**EMHAS Relocation and ED Expansion  
Guelph General Hospital  
Guelph, Ontario**

Addendum No: 1  
Date: June 14, 2024

### **ADDENDUM NO. 1**

Title  
PHASE 1 - FF&E ENLARGED PLANS & ELEVATIONS

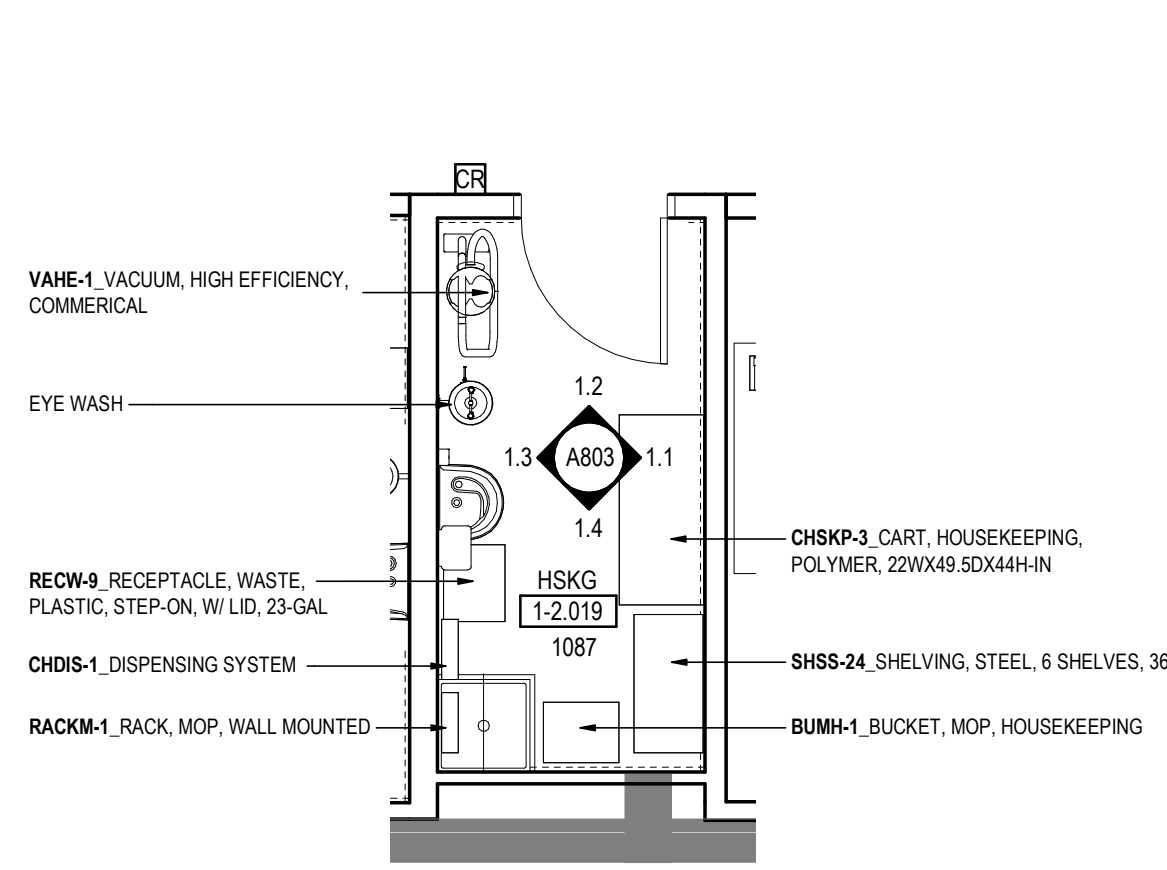
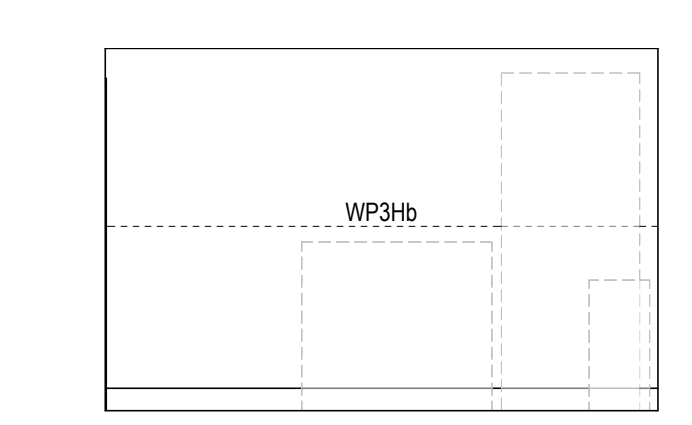
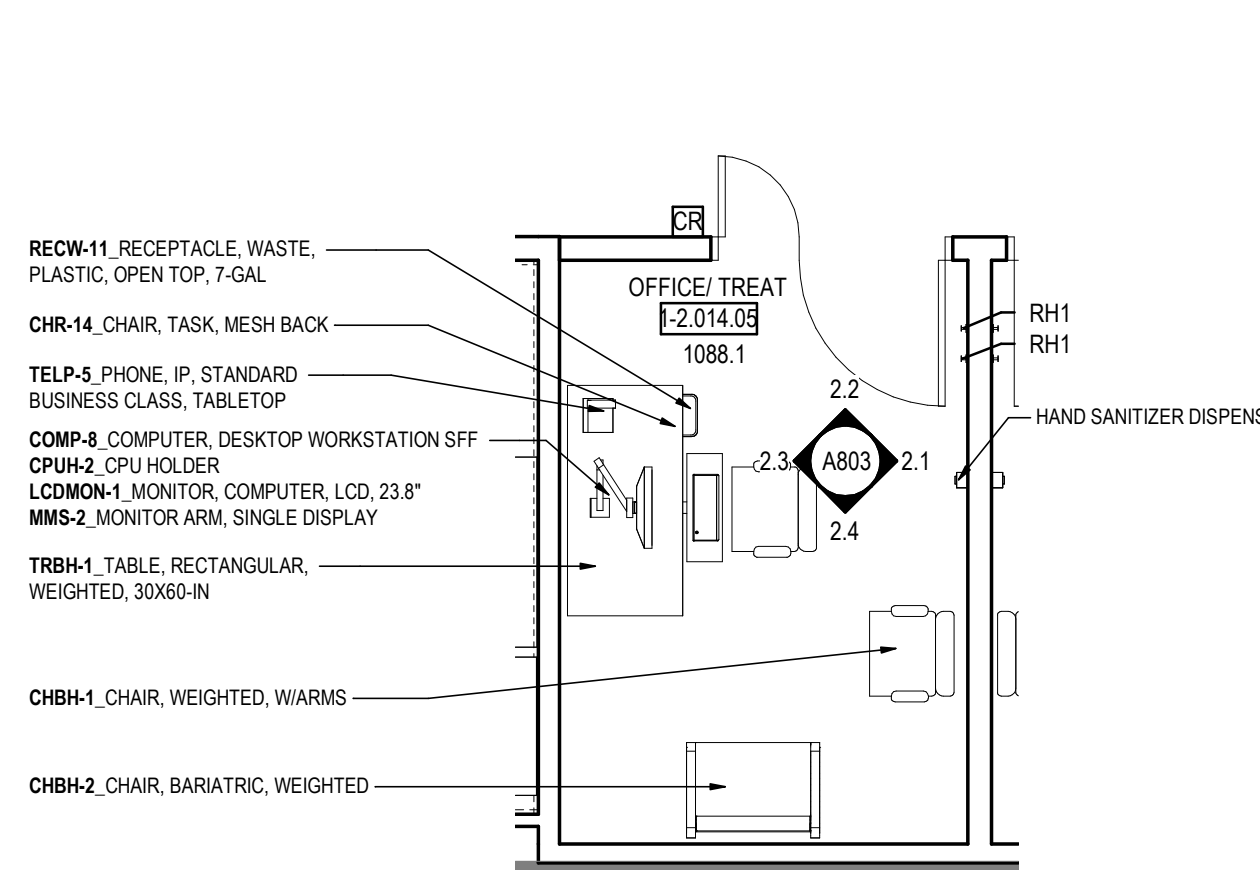
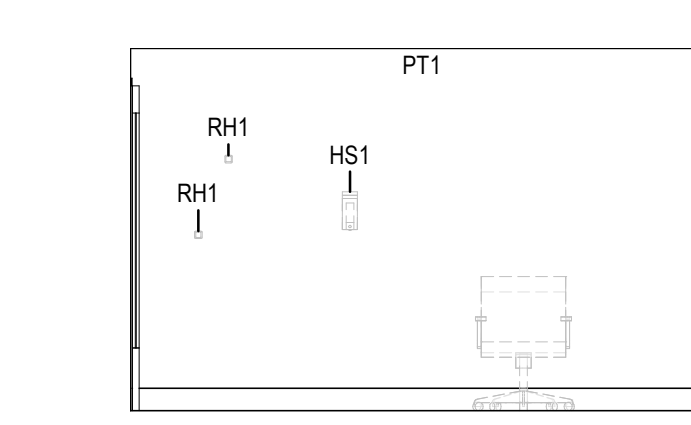
- i. Add a reference to WIN05
    - ii. Revise the note for the extent of work on the L2 roof and the south wall.
  - b. Sheet # A803
    - i. Add ice machine to room 1085 (note ice machine is already included on the FF&E)

- ii. Revise millwork
  - c. Sheet # A805
    - i. Add ice machine to room 3275 (note ice machine is already included on the FF&E)
    - ii. Revise millwork

##### **1. Drawing E302 – Phase 1 – Part Level 3 Floor plan – Power**

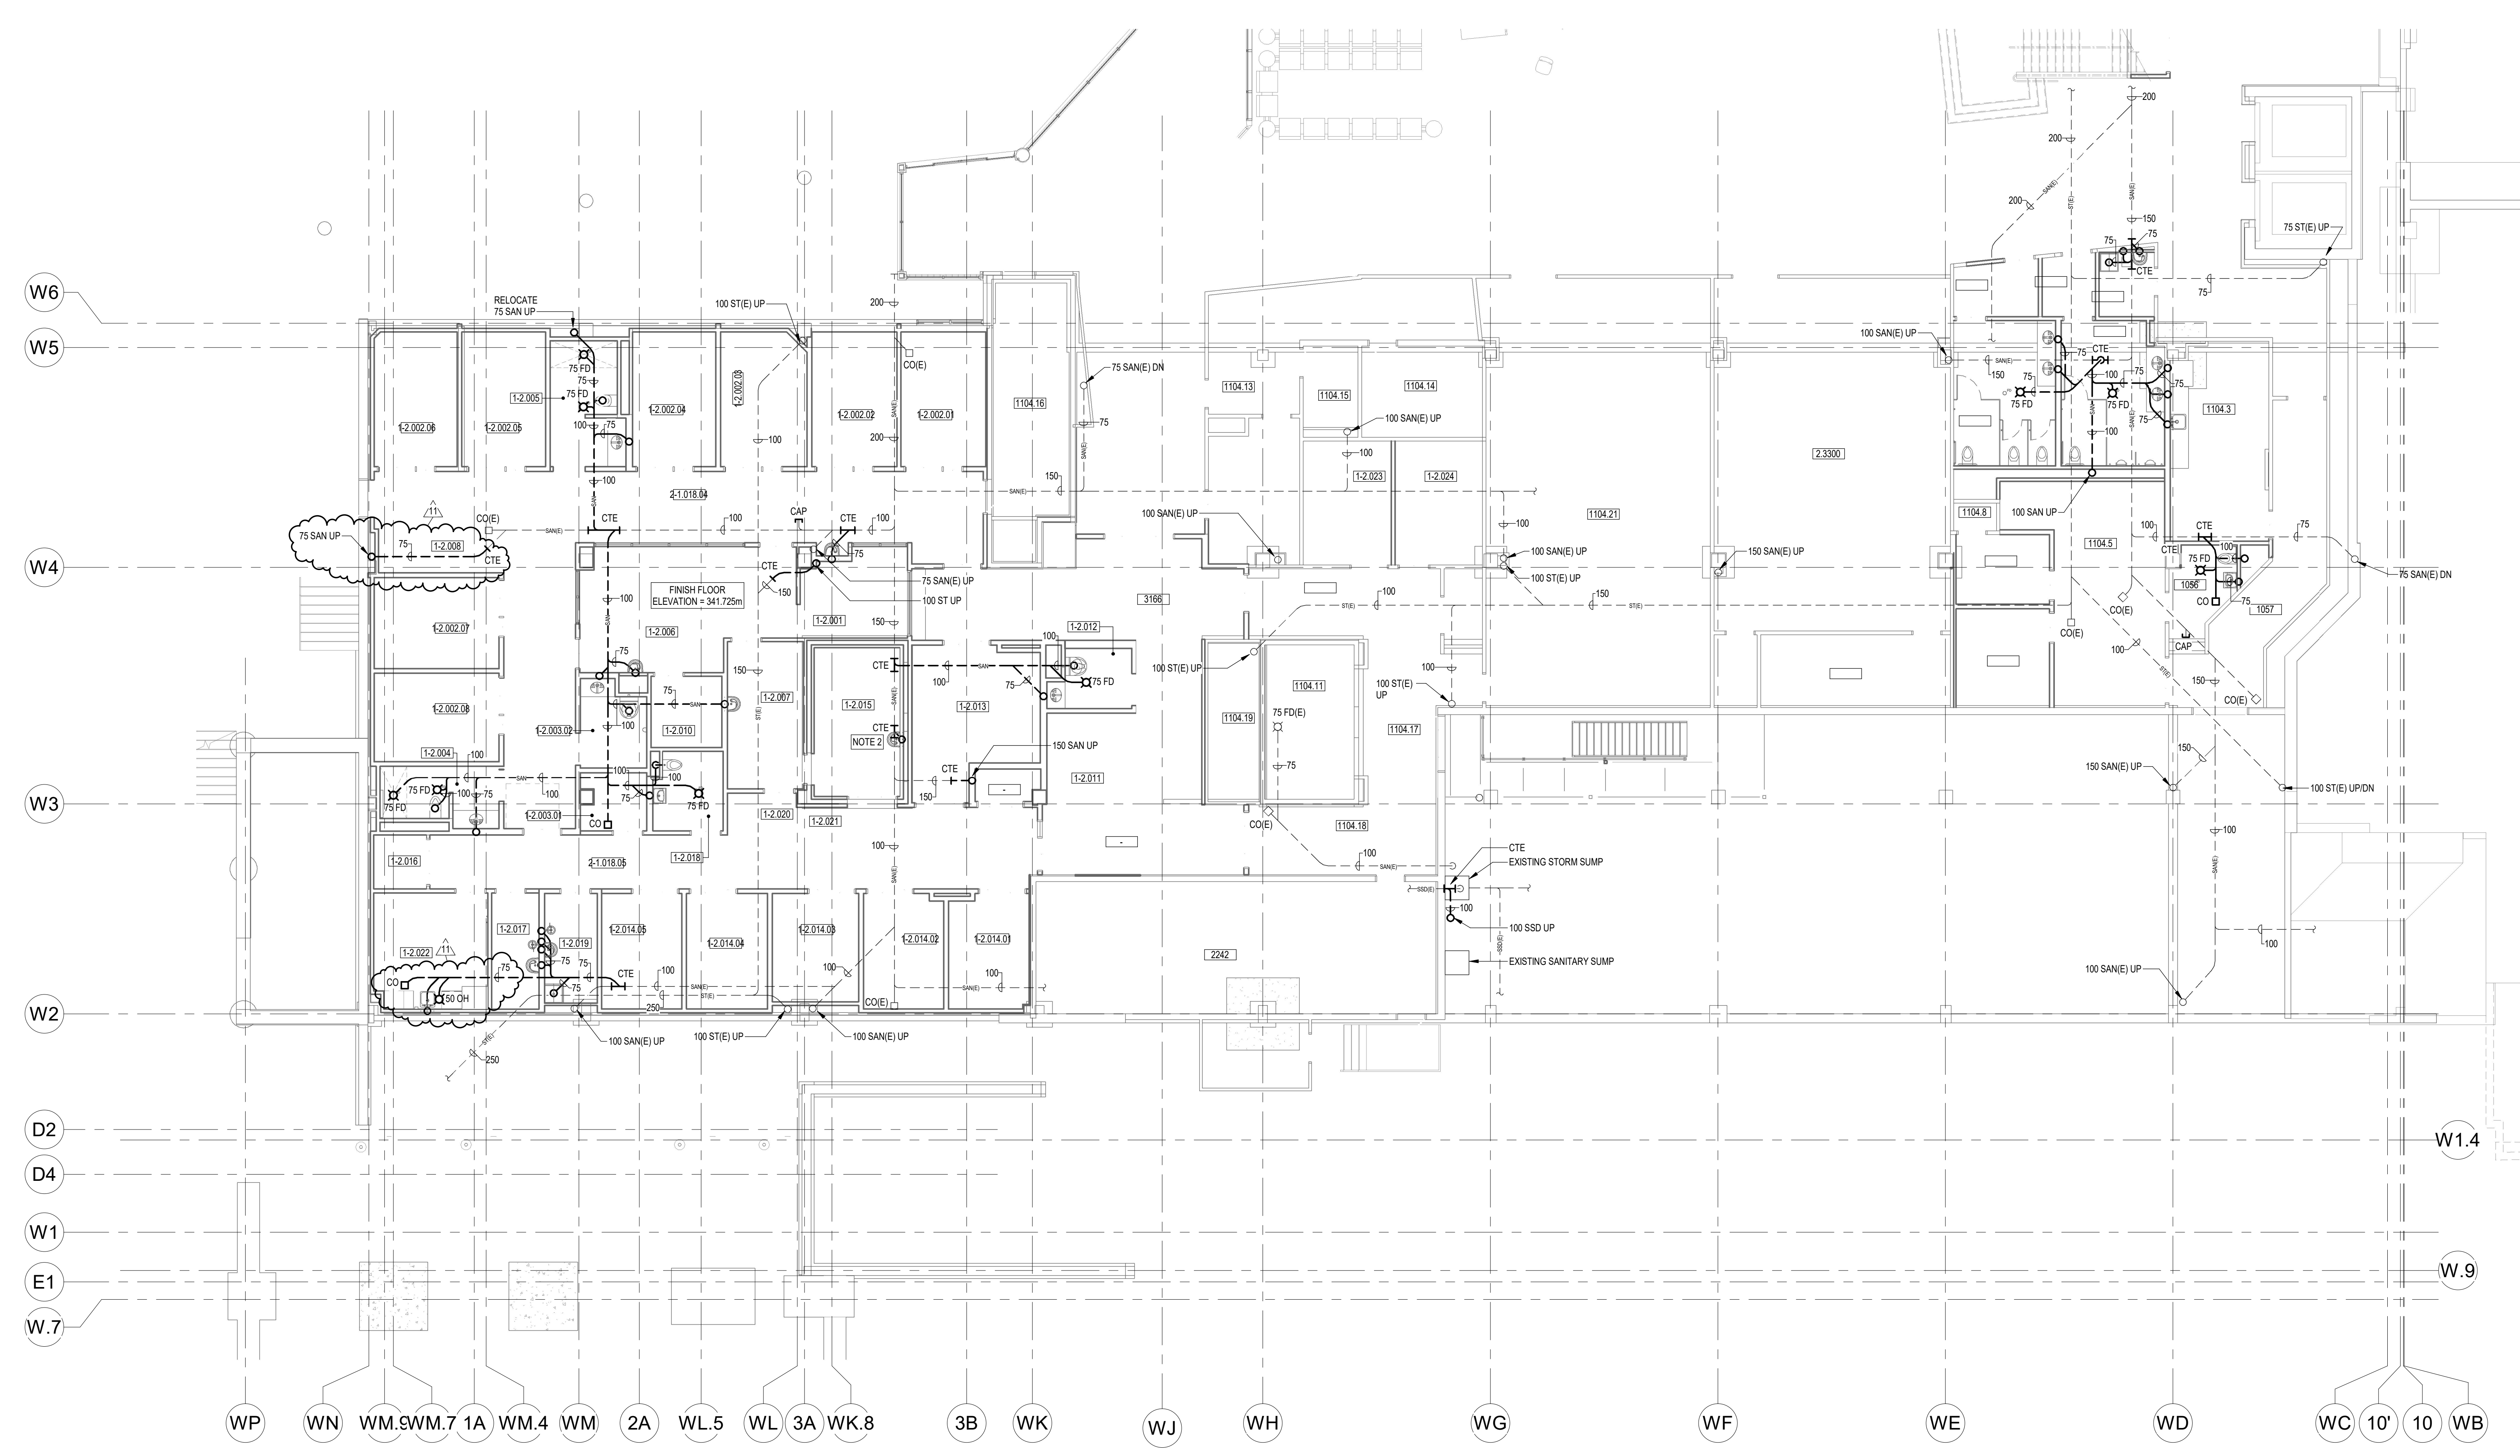
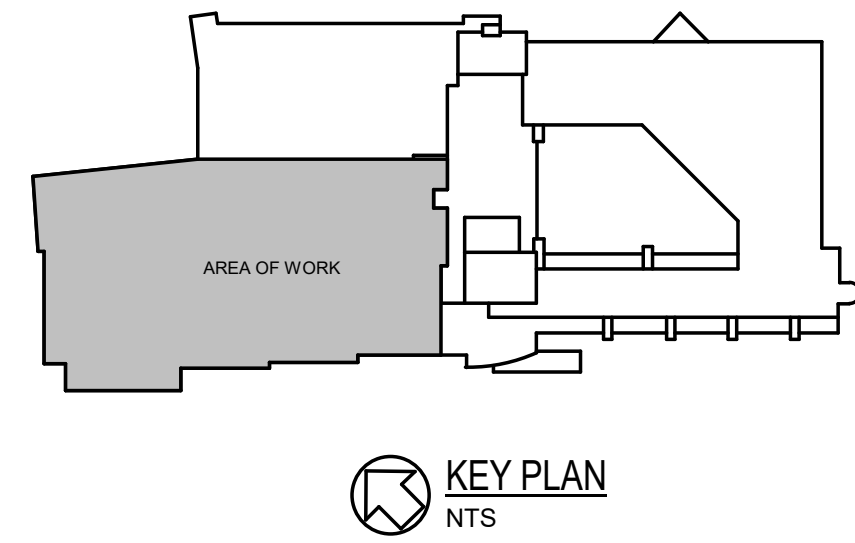
1. Provide a receptacle on the west wall of Nourish 2.3290 for ice machine. Refer to mechanical drawing M205 for exact location. Feed from circuit LP-3W-G-68. Provide a 20A 1P breaker in space 68 on panel LP-3W-G.

Title  
PHASE 1 - PART LEVEL 3 FLOOR PLAN - PLUMBING

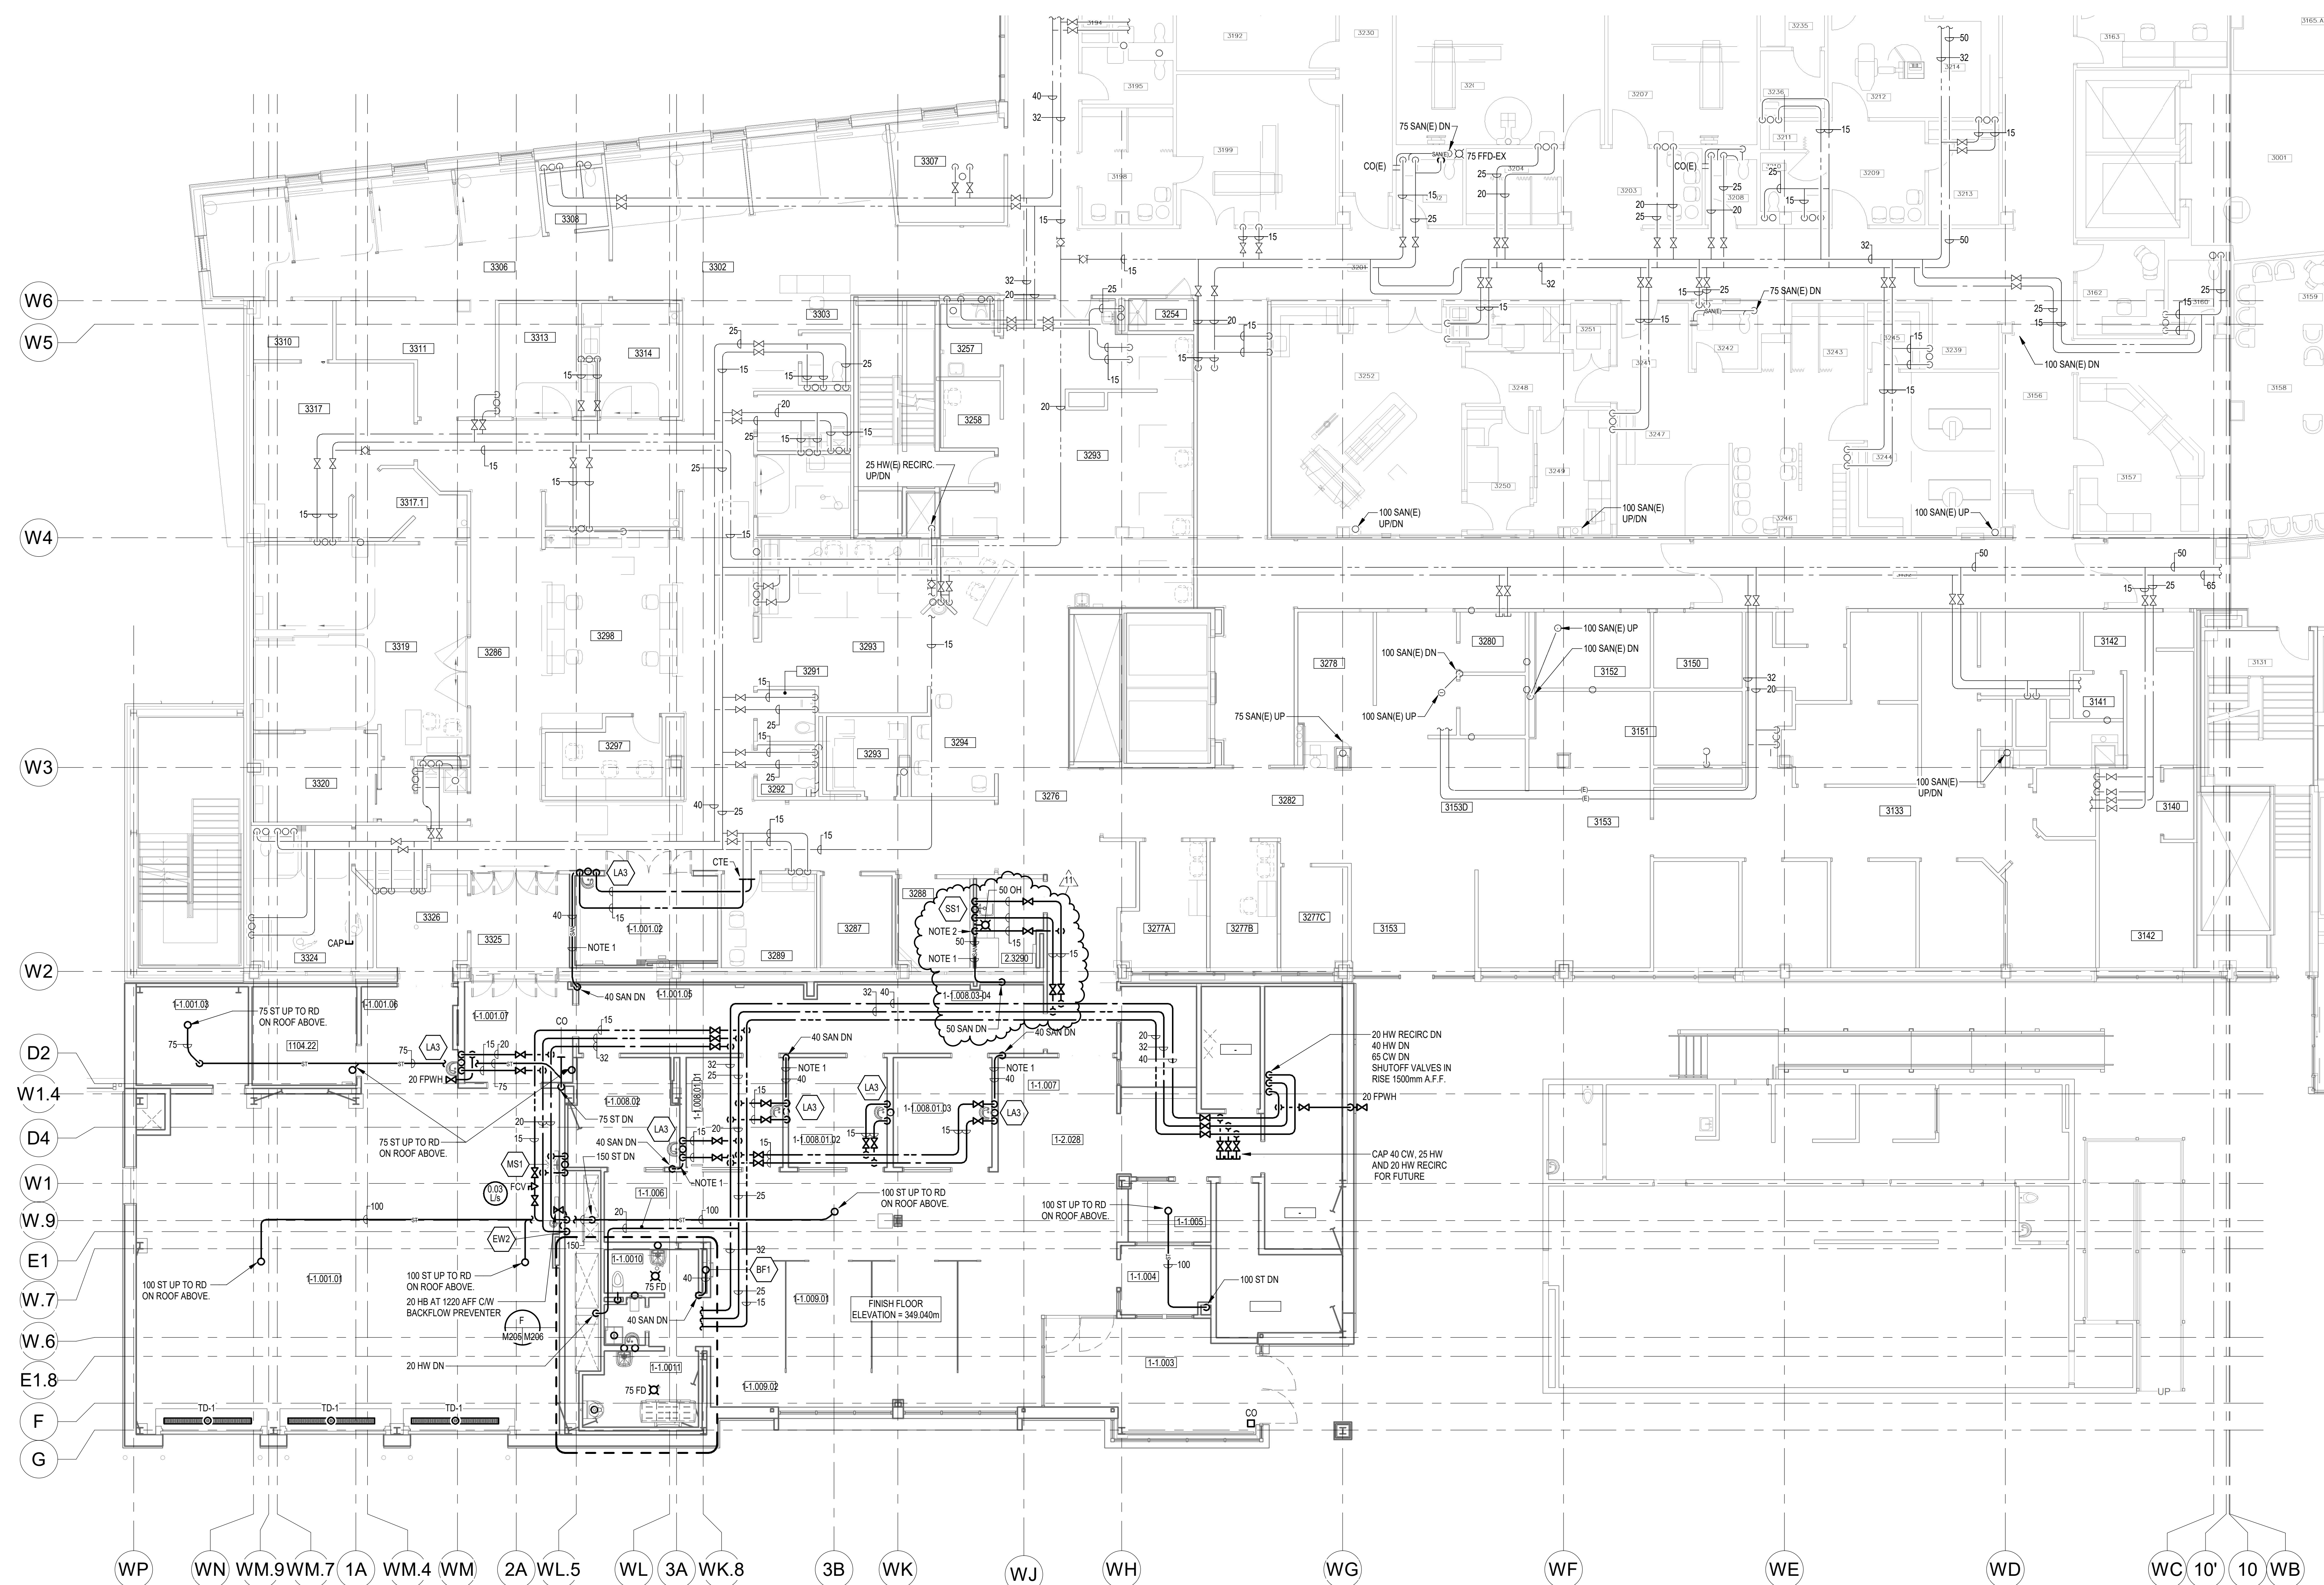
1. Revise plumbing to accommodate ice machines in rooms 1-2.022 & 2.3290.
2. Refer to attached re-issued drawings M201, M202, M203 & M205.

- SANITARY PIPING TO RUN HORIZONTALLY THROUGH WALL TO AVOID ANY NEW PIPING RUNNING THROUGH ROOM 2236 ON LEVEL 2 BELOW.
- PROVIDE 15 CW ROUGH-IN FOR ICE MACHINE CW BACKFLOW PREVENTER. RUN BACKFLOW PREVENTER DRAIN DOWN TO HUB DRAIN WITHIN MILLWORK.
